CITY OF HOLLYWOOD, FLORIDA
 UTILITY CONSTRUCTION PROJECT
CONTRACT CHANGE ORDER No. 2

CITY FILE No: 19-9119A

PROJECT: DEEP INJECTION WELLS NO.

3 AND NO. 4 PUMP STATION

DATE: 1/28/2022 SCALE: AS NOTED
SHEET: E-10-1104

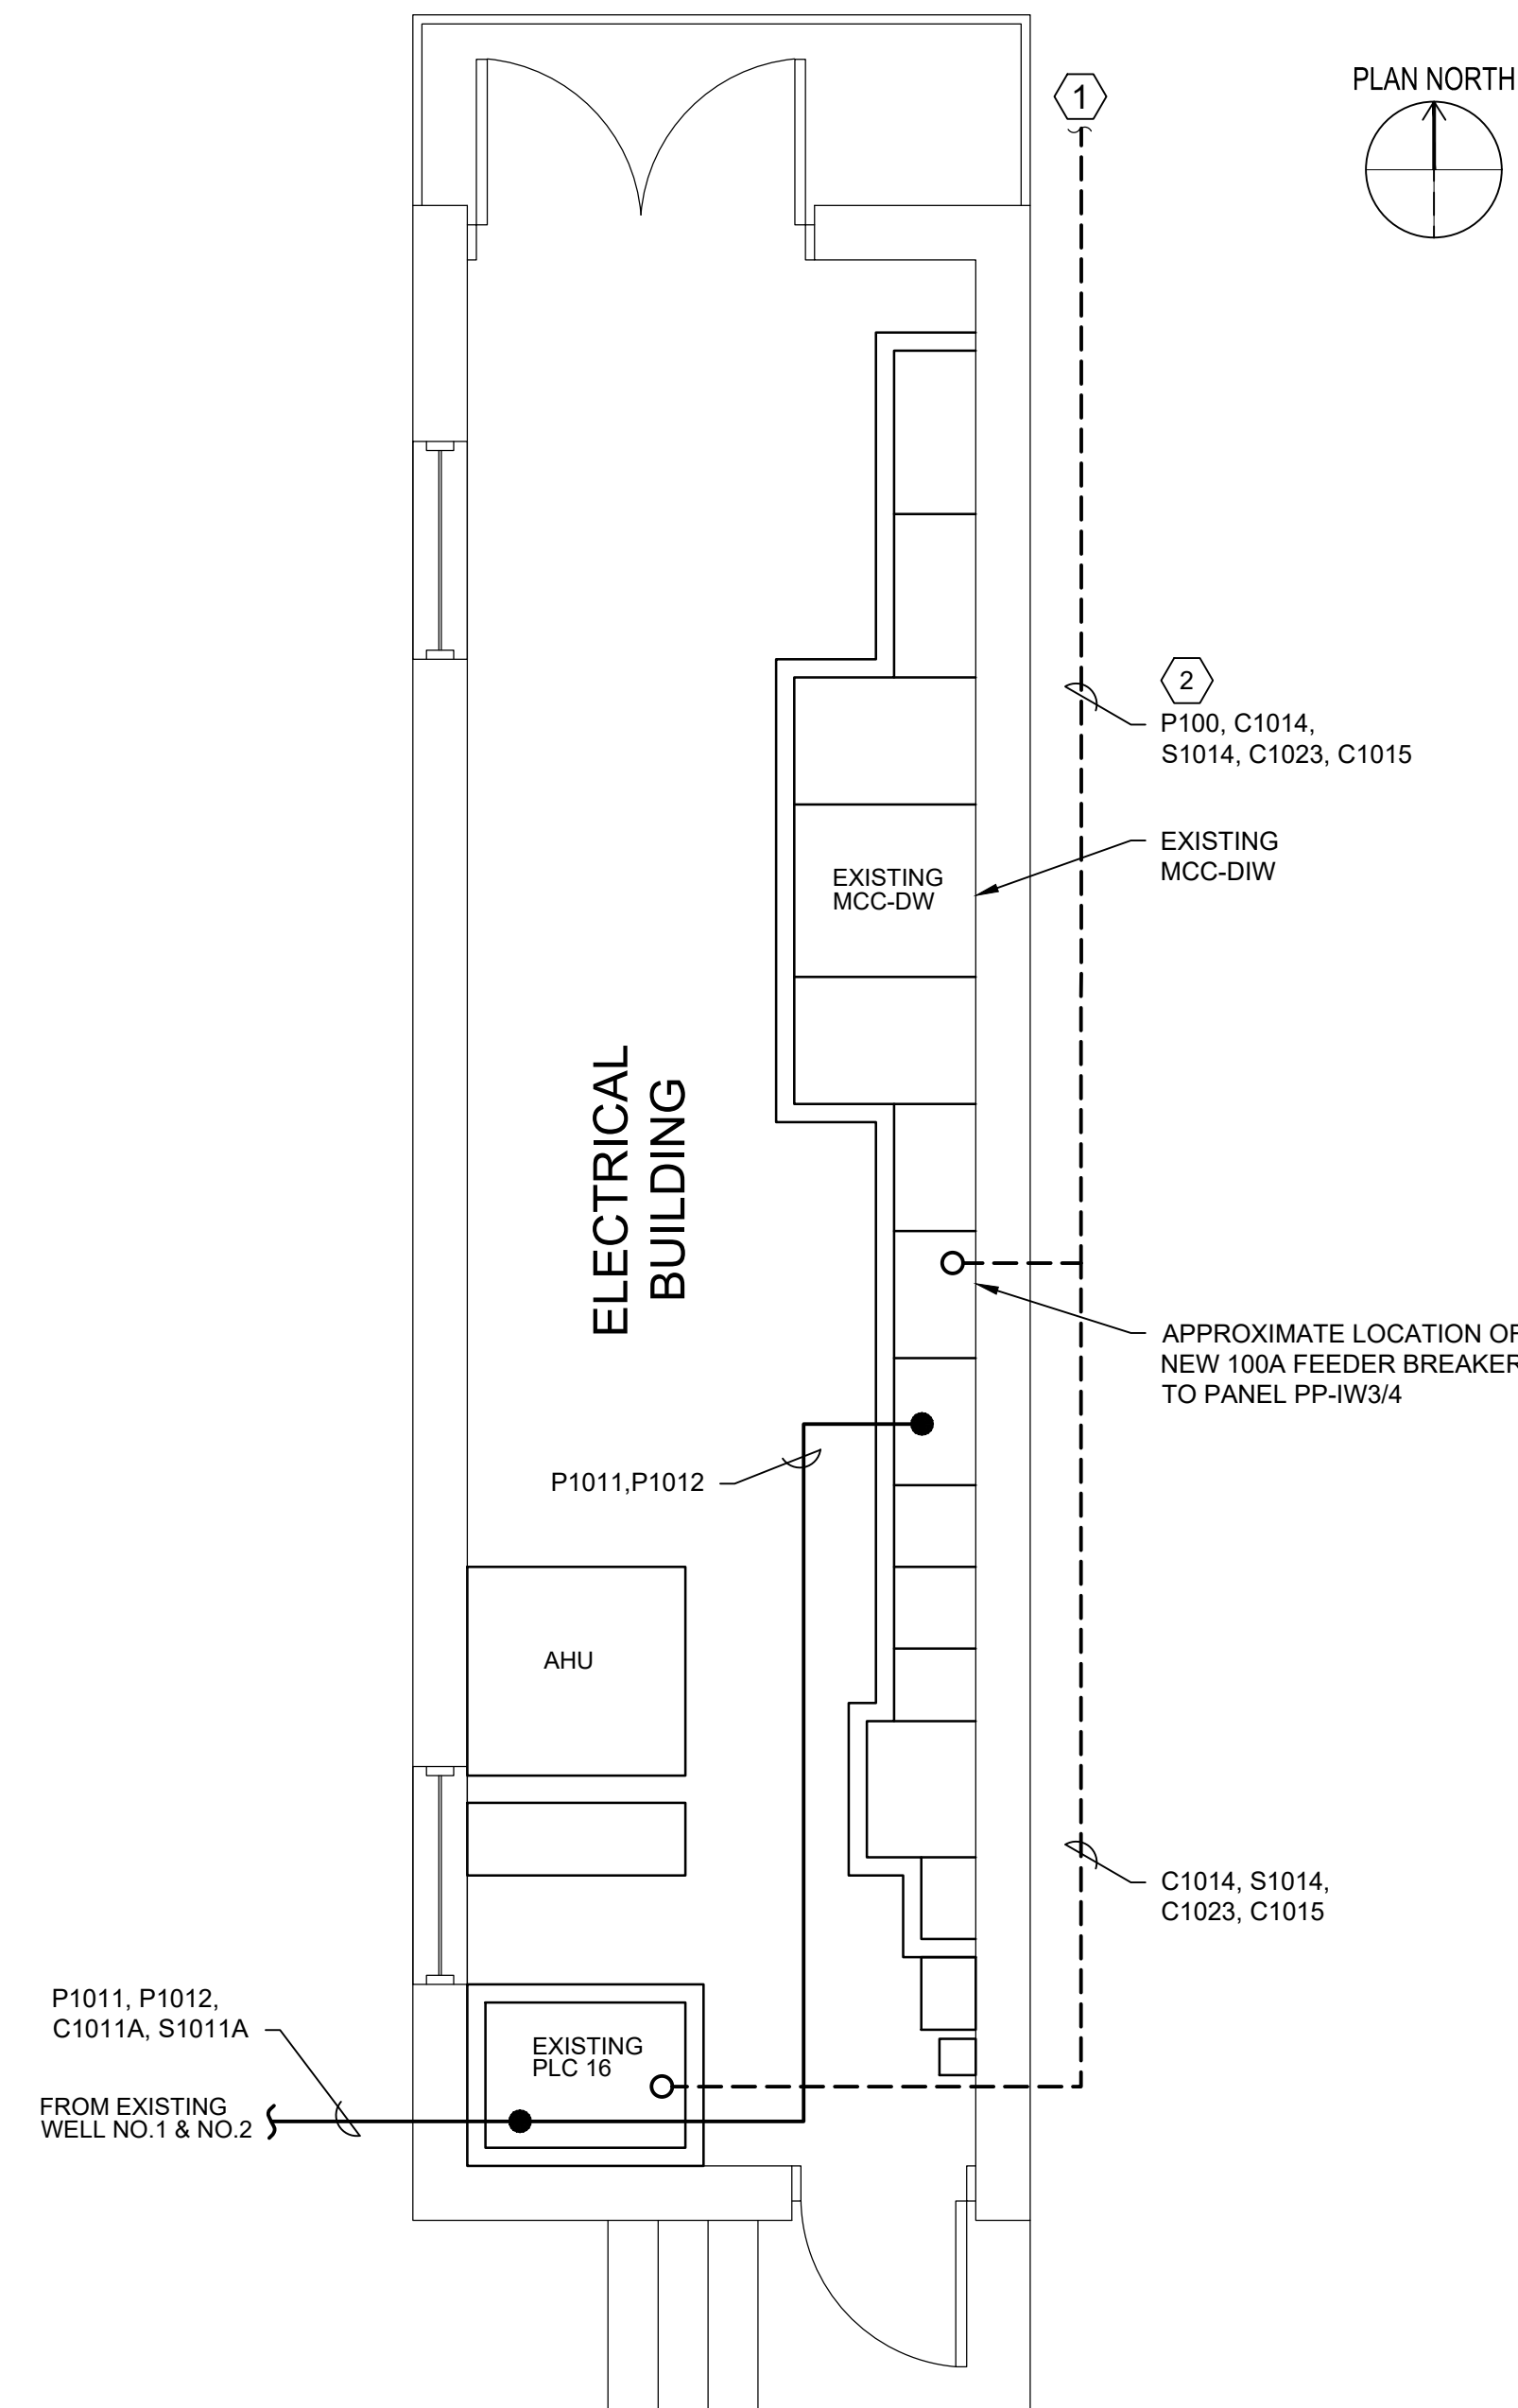
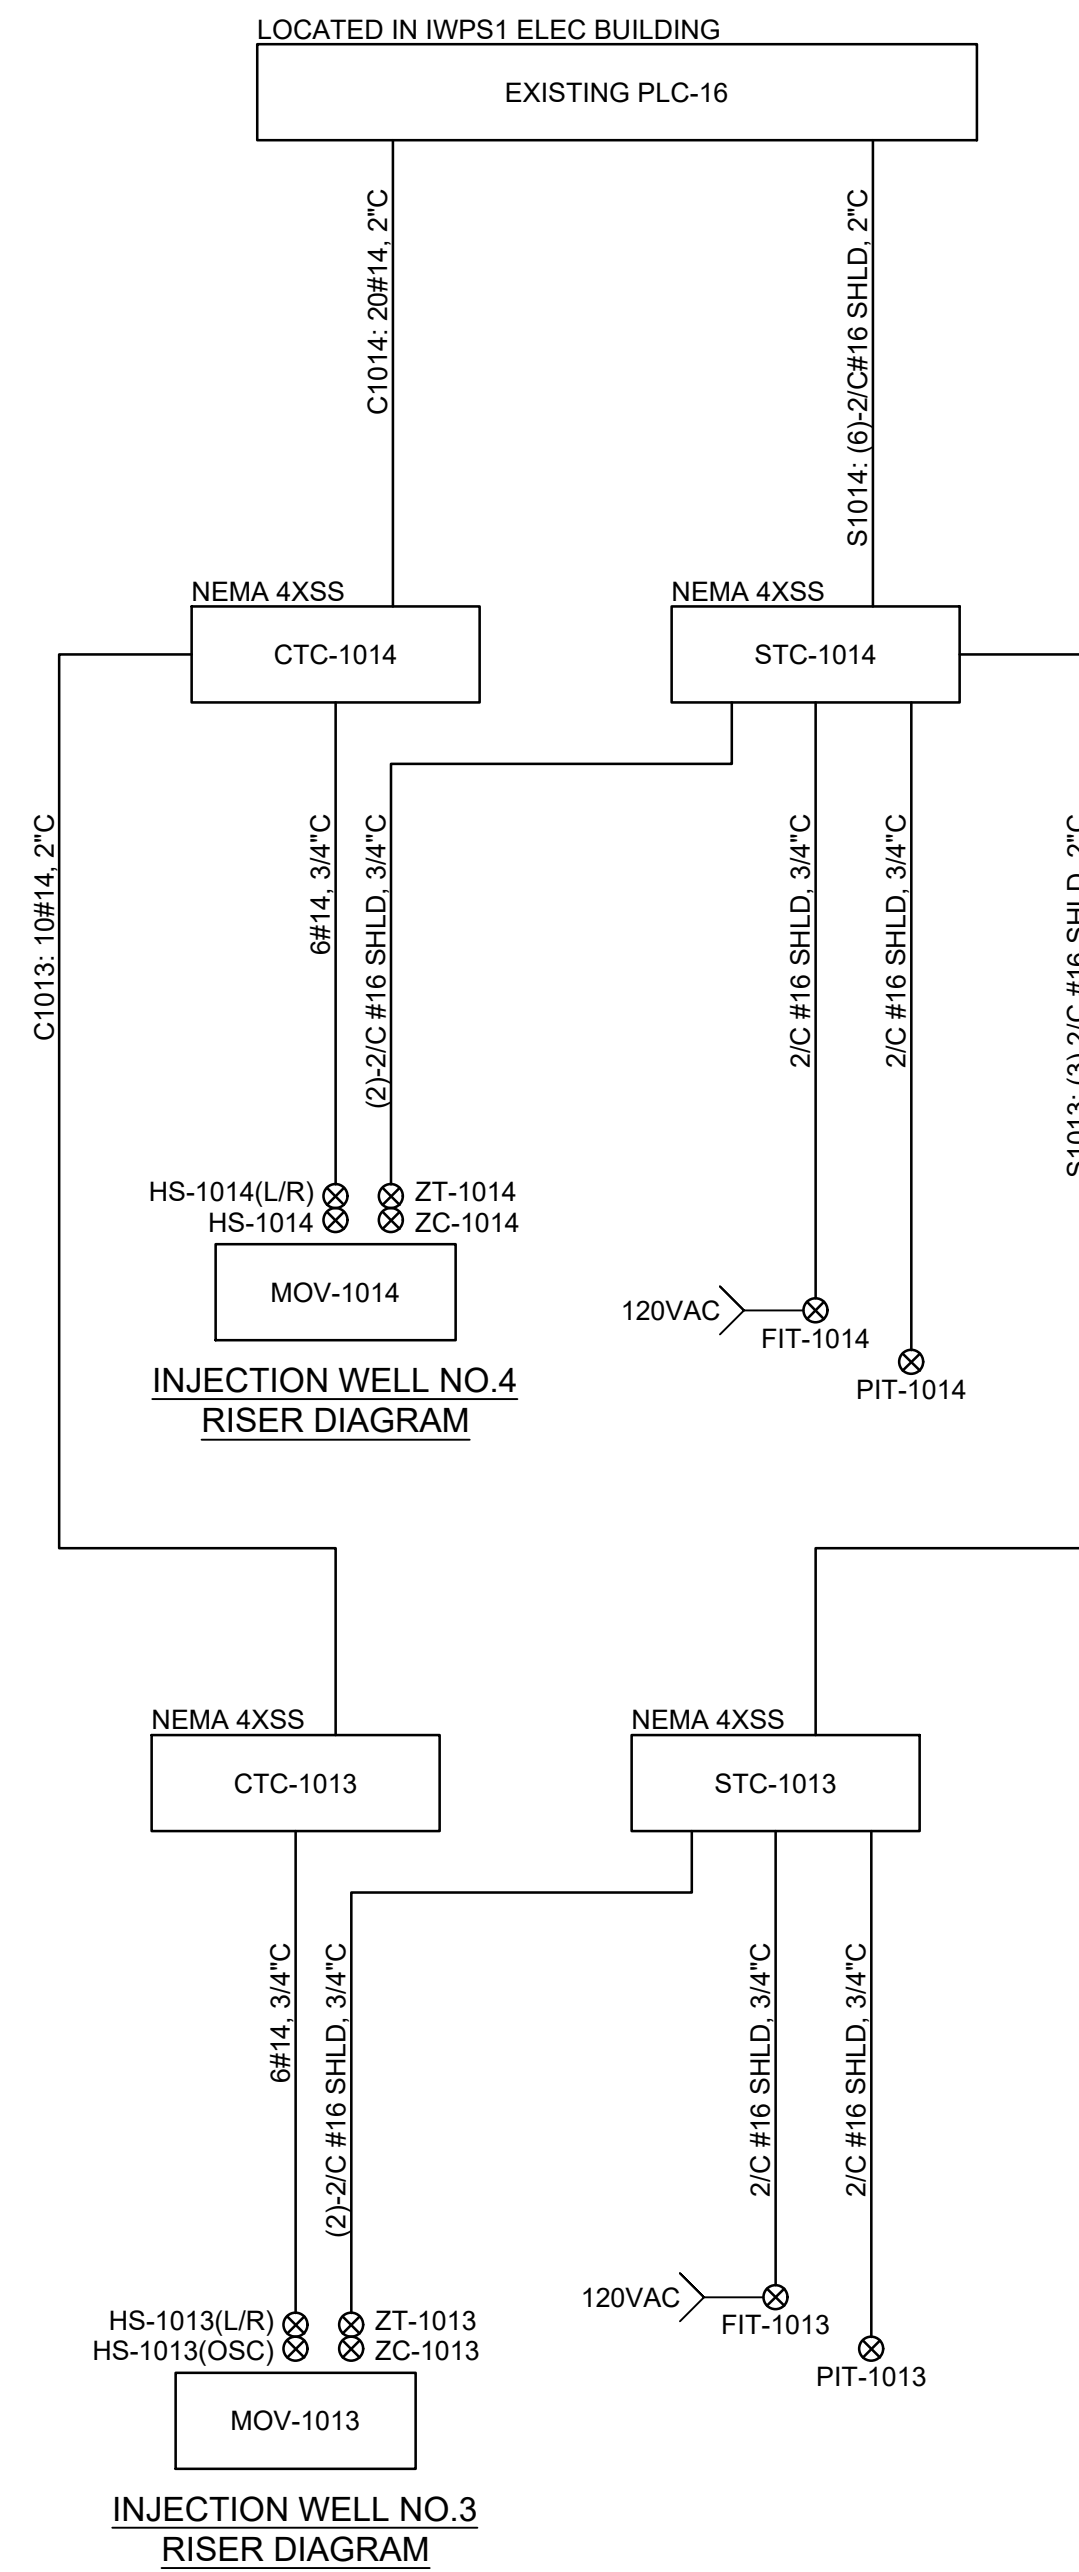
Contract Drawing E-10-1104 calls for six (6) twisted shield pair cables to run from existing PLC 16 to panel STC-1014 adjacent to Injection Well No. 4. However, seven (7) cable pairs are shown to run from STC-1014 out to instruments and another panel, hence, one cable pair needs to be added from PLC 16 to STC-1014.

Please see attached original RFI-085 for reference. This revised RFI includes a cost breakdown from Loveland Electric in regards to adding (2) TW Sh Pair from PLC-16 to STC-1014. Drawing E-10-1104 showed (6) 2/C #16 TW SH going from PLC-16 to STC-1014. Per the EOR's response to RFI-085, there should be a total of (8).

Please see attached Drawing E-10-1104 for reference. Drawing E-10-1104 shows (6) 2/C #16 TW SH going from PLC-16 to STC-1014. The drawing then shows a total of (7) 2/C Tw Sh going out of STC-1014, (2) to MOV-1014, (1) to each FIT-1014 and PIT-1014, (3) to STC-1013. There are then a total of (4) 2/C #16 TW Sh going out of STC-1013, (2) to MOV-1013, (1) to each FIT-1013 and PIT-1013. Please advise on the discrepancy of the wires going out of PLC-16 and the amount needed for the devices.

The need for additional cabling and associated cost is acknowledged. Provide a complete cost proposal to the engineer. Remember to include the breakdown of how the labor and expense costs are calculated.

There should be a total of (8)-2/C#16 shielded in 2"C from Signal Terminal Cabinet STC-1014 to PLC-16.

RFP 003 - ADDITIONAL 2/C SHIELDED CABLES

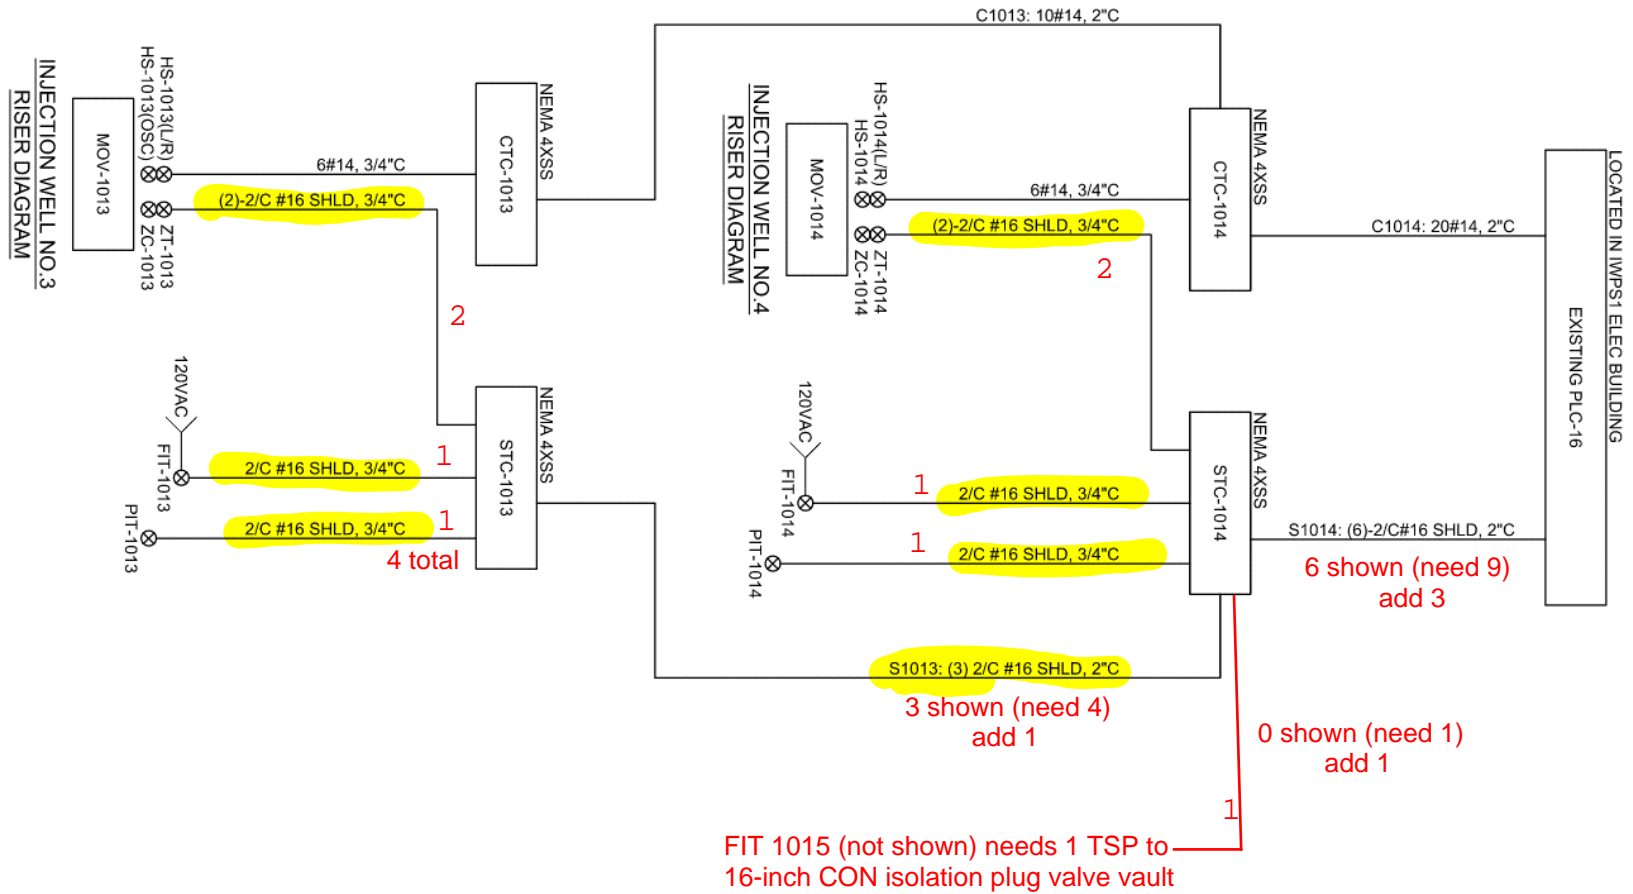
Contract Drawing E-10-1104 calls for six (6) twisted shield pair cables to run from existing PLC 16 to panel STC-1014 adjacent to Injection Well No. 4. However, nine (9) cable pairs are needed. Additional cables are also needed between panels STC-1014 and STC-1013 and some of the field instruments at Injection Well No. 3. (See the diagram attached to CP-019.)

In addition to the cable added as described in CP 009 and RFI No. 85, provide a cost proposal to furnish and install additional cables in accordance with the following description:

- Add 3 #16 twisted shielded pair cables from PLC 16 to STC 1014 for a total of 9.
- Add 1 #16 twisted shielded pair cables STC-1014 to STC-1013 for a total of 4.
- Add 1 #16 twisted shielded pair cables STC-1014 to FIT-1015.

- Add 3 TSP cables from PLC 16 to STC 1014 for a total of 9.
- Add 1 TSP cable from STC-1014 to STC-1013.
- Add 1 TSP cable from STC-1014 to FIT-1015.
